**Report Type:** CC Access Report  
**Reference Number:** 20074 B  
**Client:** Barbara Tarnawski Architects  
**Site Address:** Platypus Playground Children's Centre  
70 Glenbrook Street  
Jamisontown

# ACCESS REPORT

This Access Compliance Report is to accompany a Construction Certificate Application for the development proposed at Jamisontown Child Centre, 70 Glenbrook Street, Jamisontown NSW.

[Image description: Plan shows the provision of Accessible parking spaces]

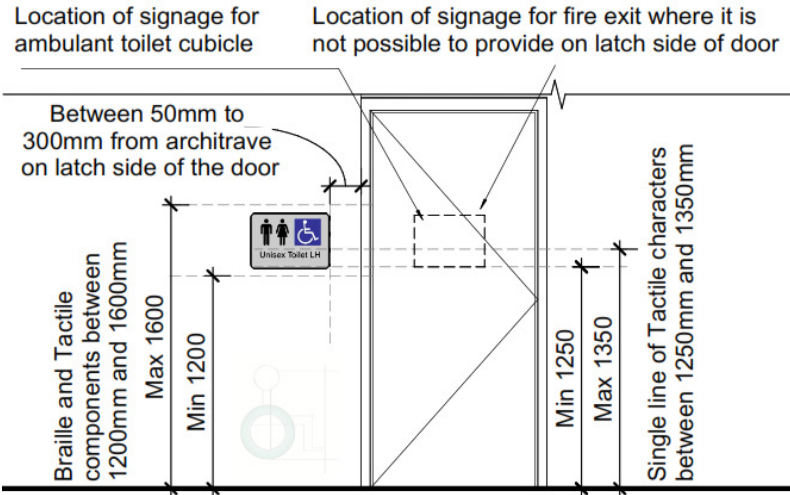
<b>Requirement</b>	<b>Class 9b</b> School - 1 Accessible car parking space per 100 spaces provided Other assembly building - 1 Accessible car parking space per 50 spaces provided and then additional 1 Accessible car parking space per additional 100 spaces provided
<b>Compliance Comments</b>	Complies. Total number of Accessible parking spaces required / provided in the development = 1
